SOLV/EDC & CMP PLANT NOTIFICATION OF PROCESS CHANGE CHECKLIST

Actual Date of Change: ~~6/23/97~~ 6/27/97 Area: HCl Purification Equipment: K-55

Description and Location of Change (Scope): Modify the K-55 seal that the atmospheric side of the seal can be purged with nitrogen. Install a permanent N2 header with a regulator to supply the continuous purge to the seal

Durametallic Specialty Systems Corporation Durham, N. C. 27604 (704) 281-1776	Model: 70-2241	Part No.
	Qty: 20-281476	
Drawn By: RJP	Part No.	Qty:
Checked: RJP	20-281476	5
Notes:

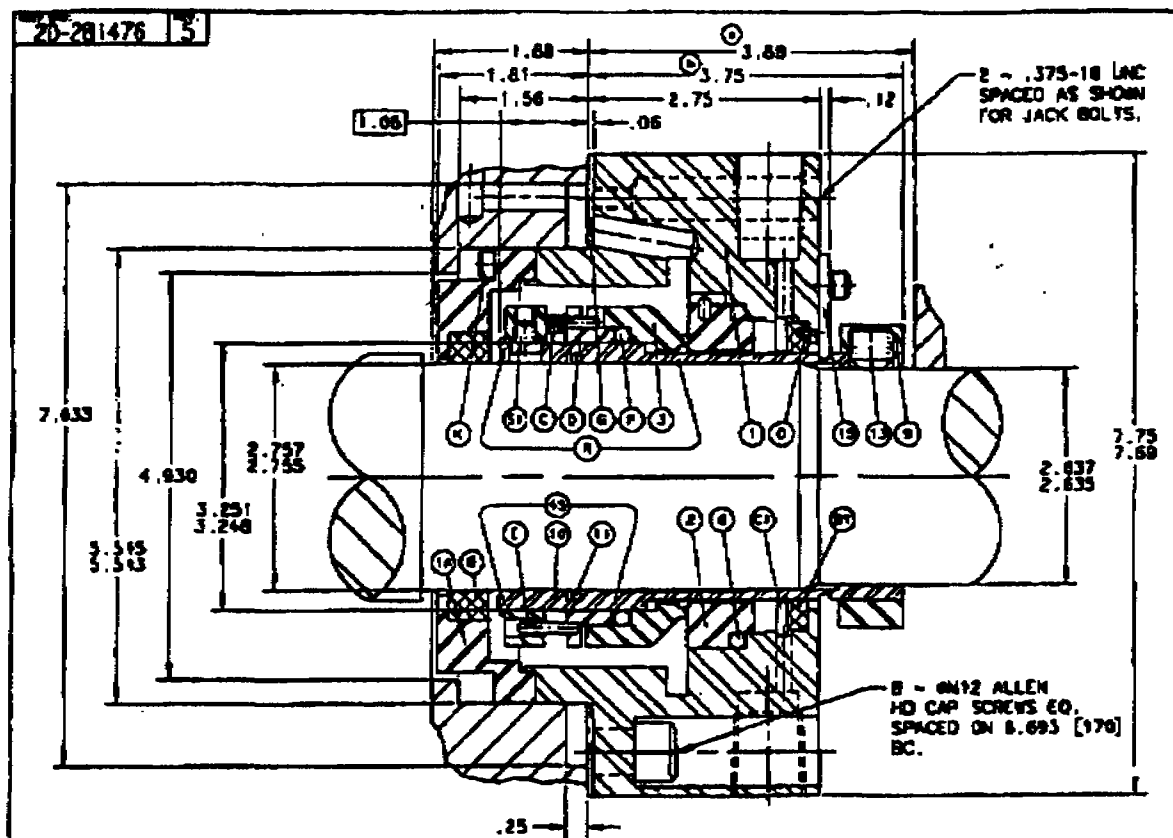
Technical Basis for Change: Installation of the N2 purge will help eliminate failure due to external corrosion.
